TOWN OF ADDISON
BUILDING REPORT

Facility Information: Facility Name: Police & Courts Building

Address: 4799 Airport Parkway City: Addison County: Dallas

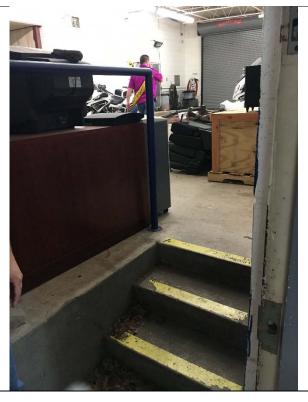
Violation 5 - There is no accessible route to the 2nd floor of the facility.

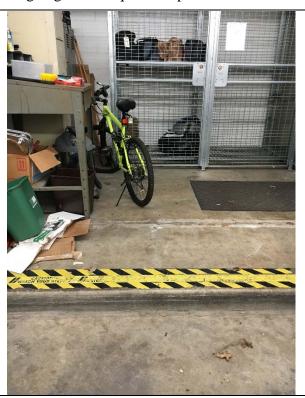
Violation 6 - The door leading from the main building into the jail only has a 7" maneuvering clearance on the pull side.

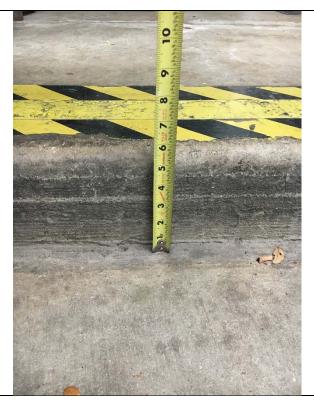
Violation 7 - Access into the garage area requires steps.

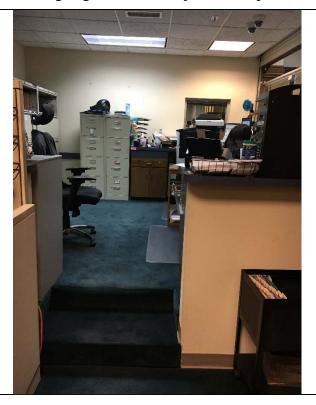
Violation 8 - The route from the garage area into the jail area requires a 6" step.

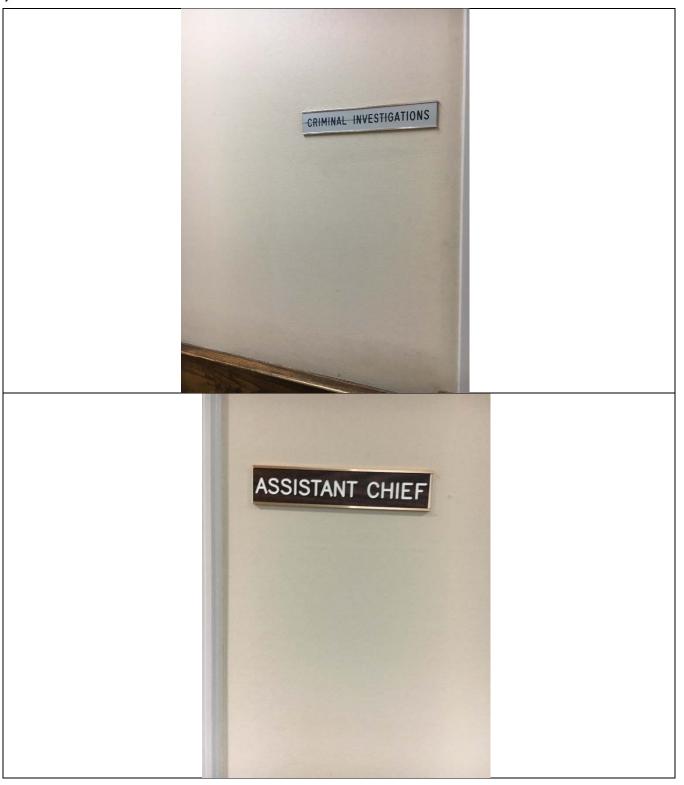
Violation 12 - The back entrance door for "Authorized Personnel Only" requires a 7.5" step up.

Provide an accessible curb ramp to provide access to the door.

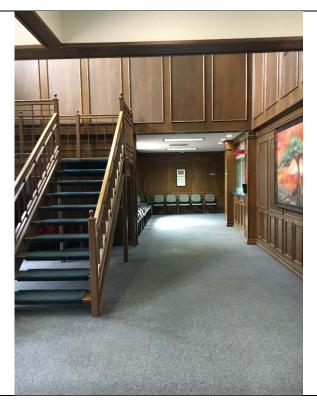
Violation 19 - The counter at the Municipal Court window is at $47\ 1/4$ " where 36" maximum is required.

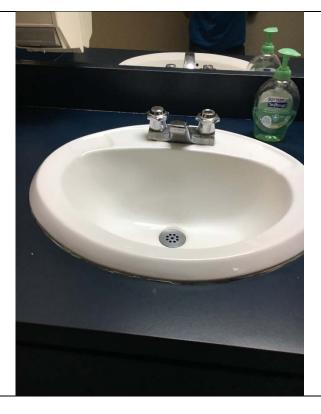
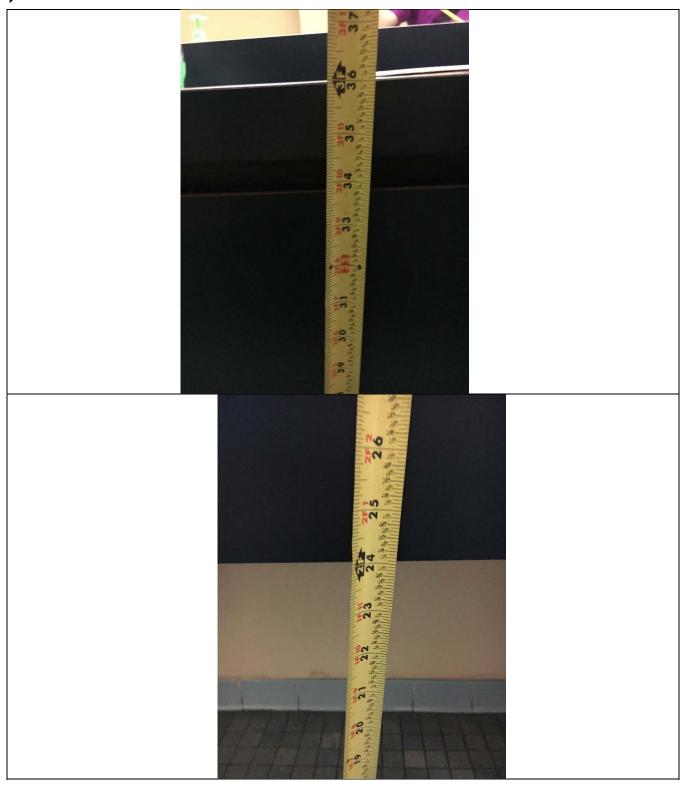
Violation 27 - The Women's restroom outside Courts and Records has a 5/8" change in level to enter the restroom.

Possible Solutions: Modify entrance into the restroom.

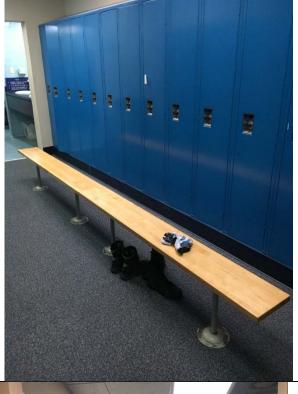
Violation 34 - There is a 3/4" change in level at the entrance door into the Women's locker room.

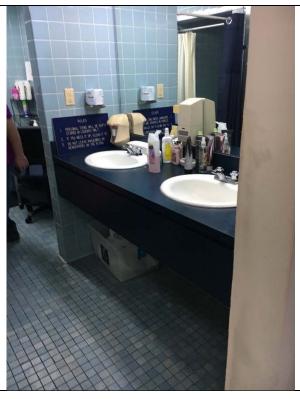
Violation 37 - There are no accessible stalls provided in the Men's and Women's locker rooms.

Possible Solutions: Modify rooms to provide an accessible toilet compartment.

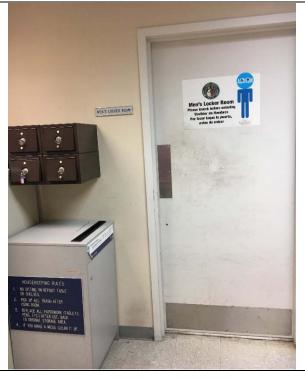
Violation 39 - The lavatories in the Men's and Women's locker rooms are mounted at 36", have faucet controls that require grasping and twisting to operate and the pipes are not protected.

Possible Solutions:	Provide at least one accessible lavatory in the Men and Women locker room restrooms.		
Violation #39 Cost:	\$4,200 Priority Level 4

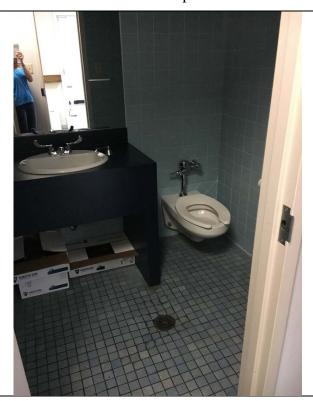
Violation 40 - There is only a 7-1/2" maneuvering clearance on the pull side of the Men's locker room door, a minimum of 18" is required.

Possible Solutions: Modify door to provide 18" clearance.

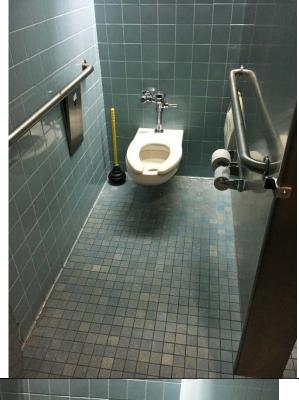
Violation 45 - Men's and Women's restroom outside courtroom - lavatory water lines are not protected.

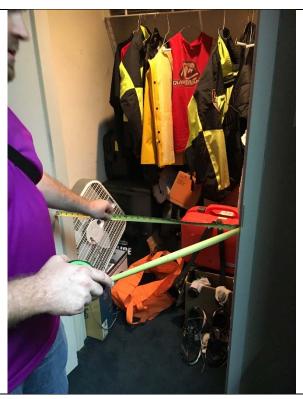
Violation 66 -The storage closet in the dispatch room has a door opening of only 29" where a minimum of 32" is required.
